Access Compliance Report Public Rights-of-Way (Curb Ramps)

Main Street: CRAWFORD_CANYON_RD Cross Street: NEWPORT_BLVD Location: NE

ADA ID: RPRK211012171622 Ramp Type: Type 1 - Perpendicular Diagonal Initial Pass/Fail: Fail Overall Compliance: No Severity Score: 2

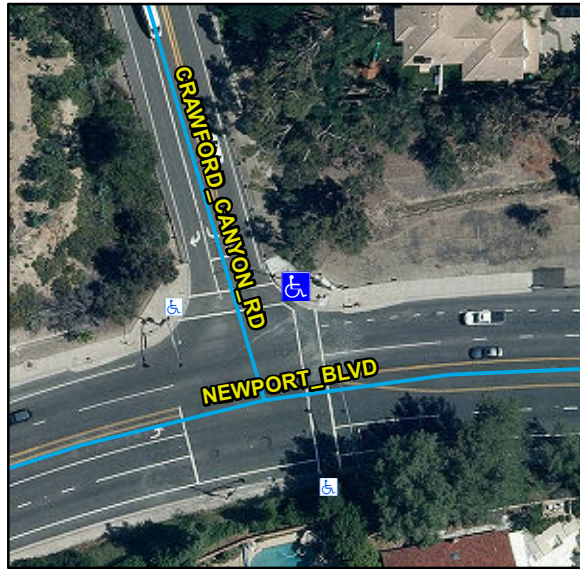
Compliance	Description	Data	Compliance	Description	Data
N/A	Ramp Length (in)	110	N/A	Flare Type LT	
Yes	Ramp Width (in)	48			N/A
Yes	Ramp Run Slope (%)	8.3	N/A	Flare Slope LT (%)	N/A
No	Ramp Cross Slope (%)	4.1	N/A	Flare Traversable LT	N/A
N/A	Landing Present	N/A	N/A	Flare Type RT	
N/A	Landing Length (in)	N/A			N/A
N/A	Landing Width (in)	N/A	N/A	Flare Slope RT (%)	N/A
N/A	Landing Run Slope (%)	N/A	N/A	Flare Traversable RT	N/A
N/A	Landing Cross Slope (%)	N/A	N/A	DWS Provided	N/A
N/A	Landing Movement Obstructed?	N/A	N/A	DWS Contrast	N/A
	Landing Movement Type	N/A	N/A	DWS Length (in)	N/A
N/A	Landing Shared	N/A	N/A	DWS Full Width	N/A
N/A	Clear Space	Yes	N/A	DWS Offset Left (in)	N/A
N/A	Clear Space To Crosswalk (in)	48	N/A	DWS Offset Right (in)	N/A
N/A	Marked Crosswalk 1	Yes	N/A	Marked Crosswalk 2	Yes
	Crossing 1 Direction	W		Crossing 2 Direction	S
	Marked Crosswalk 1 Width (in)	144		Marked Crosswalk 2 Width (in)	144

N/A	Ramp Inside Crosswalk 1	Yes	Yes	Ramp Inside Crosswalk 2	Yes
	Crossing 1 Slope (%)	4.5		Crossing 2 Slope (%)	3.2
	Crossing 1 Cross Slope (%)	1.2		Crossing 2 Cross Slope (%)	5.8
N/A	Gutter Ponding	N/A	N/A	Curb Slope	2.1
No	Gutter Lip Height (in)	0.25		Road Run Slope (%)	0
N/A	Gutter Run Slope (%)	N/A		Road Cross Slope (%)	5.3
N/A	Gutter Cross Slope (%)	N/A			
Yes	Overall Surface Condition: Acceptable		No	Perp Joint Present	No
	Cross Gutter Present?	No		Spandrel Present?	No
	Replace Cross Gutter?	N/A		Replace Spandrel?	N/A

Remove & Replace Curb Ramp With Two New Directional Ramps or Equivalent. Grind Gutter Lip.
